SUBJECT: WATTS BAR NUCLEAR PLANT - REQUEST FOR ADDITIONAL
INFORMATION (RAI) REGARDING TRITIUM PRODUCTION - INTERFACE ISSUE
NUMBER 2 - PROCUREMENT AND FABRICATION ISSUES (TAC NO. MB1884)

ENCLOSURE 1
TENNESSEE VALLEY AUTHORITY
WATTS NUCLEAR PLANT (WBN)
UNIT 1
DOCKET NO. 390
INTERFACE ITEM NUMBER 2
PROCUREMENT AND FABRICATION ISSUES

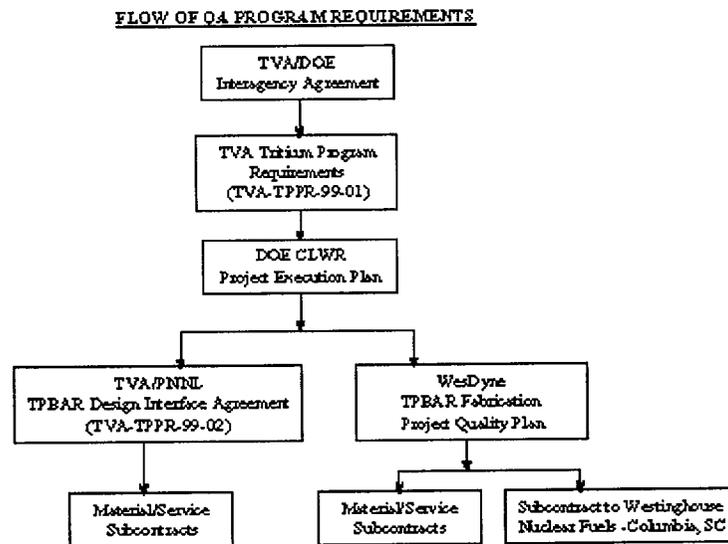
NRC needs "evidentiary material" from TVA that the manufacturers of the tritium assemblies (including subcontracted components/subassemblies) have quality assurance programs that comply with Appendix B requirements. Please discuss how TVA imposes QA requirements on the suppliers (probably through the procurement documents) and provide evidence of same. Also, please provide assurance that the suppliers have adequately implemented QA programs in conformance with Appendix B. (Is this accomplished through NUPIC audits or, for the special case of tritium, through supplier audits TVA conducts?). Please send us the audit reports and supplementing information which would support a conclusion that the suppliers have established and implemented QA programs in conformance with Appendix B requirements. Supplementary information might include supplier exceptions to TVA QA program or additional commitments to national standards by the supplier, which go beyond TVA's QA program in areas such as subcontracting, design, or manufacturing.

TVA Response: (Note: Some enclosures only contain excerpts from referenced documents) TVA has no direct procurement document with any of the material, service, or component suppliers of TPBARs. TVA has an Interagency Agreement with the Department of Energy (DOE) (Enclosure 2) that requires DOE to flow down TVA requirements to suppliers and which requires the major DOE direct suppliers to be on the TVA acceptable supplier list (ASL). The TVA technical, functional, and quality requirements for the design, procurement, and fabrication of TPBARs are contained in a TVA Tritium Production Program Requirements Document (TVA-TPPR-99-01) (Enclosure 3). There are currently two DOE direct suppliers involved in the supply of TPBARs. The Pacific Northwest National Laboratory (PNNL), a DOE owned site operated by the Battelle Memorial Institute, performs TPBAR design and procurement activities. WesDyne International LLC performs procurement and fabrication activities. Both of these suppliers are on the TVA ASL for their respective current scopes of work.

DOE identifies the TVA requirements to project participants in section 5.2.1 of the CLWR Project Execution Plan (Enclosure 4). Evidence of project participant implementation of the TVA requirements is demonstrated through a TPBAR Design Interface Agreement between TVA and PNNL (Enclosure 5) and the WesDyne Project Quality Plan for TPBAR Fabrication (Enclosure 6). Sub-suppliers are required to meet the applicable QA program requirements as determined by the procuring organization (i.e. PNNL or WesDyne). The DOE direct suppliers have been audited by TVA to ensure compliance with Appendix B requirements. PNNL was initially placed on the TVA ASL under the Lead Test Assembly Project and maintained on the ASL through annual evaluations and triennial audits (Enclosure 7). WesDyne was recently placed on the TVA ASL after completion of an initial qualification audit (Enclosure 7).

The following diagram depicts a summary view of the flow of QA program requirements.
